Product Change Notification						PCN FMBB and FSS case 48 redesign		
owner	creation date	release date	released by	change order no	rev	page	D40 057 333	
doriaan	12.05.2021	12.05.2021	blumhe	2021809	В	1 of 2	D10-057-322

Product Change Notification						PCN FMBB NEO MC MD - earth position		
owner	creation date	release date	released by	change order no	rev	page	D40 020 072	
segatro	07.10.2019	07.10.2019	romanogu	2018488	С	1 of 2	D10-039-972

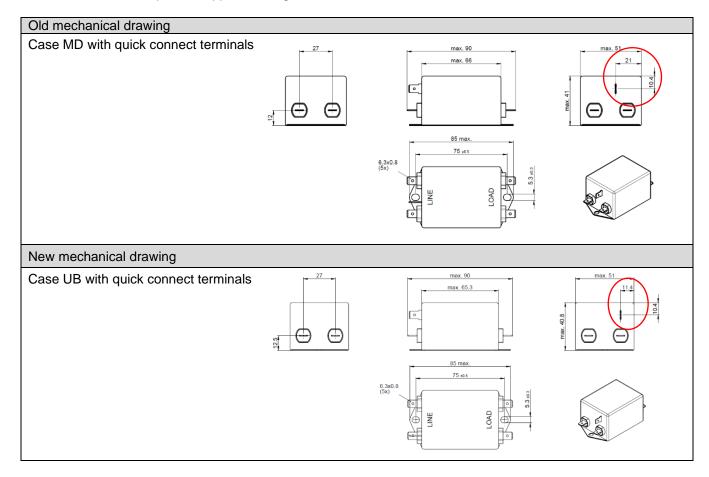
Changed ground terminal position

Modification of the product appearance, ground faston terminal moved

Form Yes Note new ground terminal position

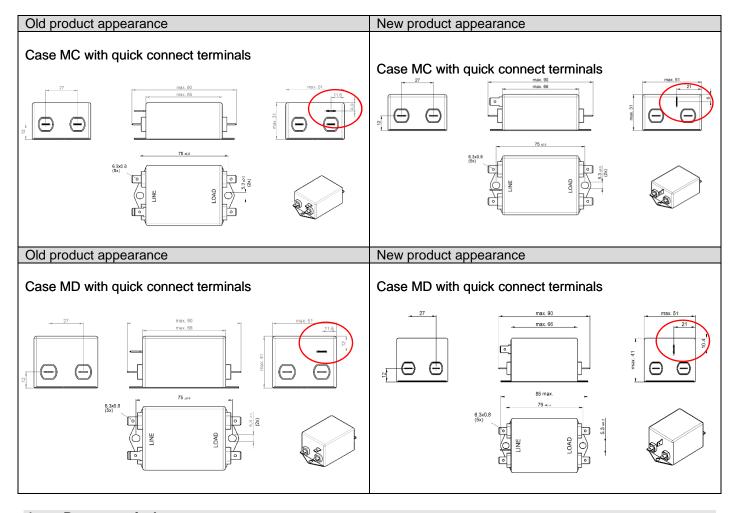
• Change of protective earth terminal on FMBB NEO filters case MC and MD

Moved position and turned protective earth terminal to a vertical position

Form Yes Change of position of protective earth terminal
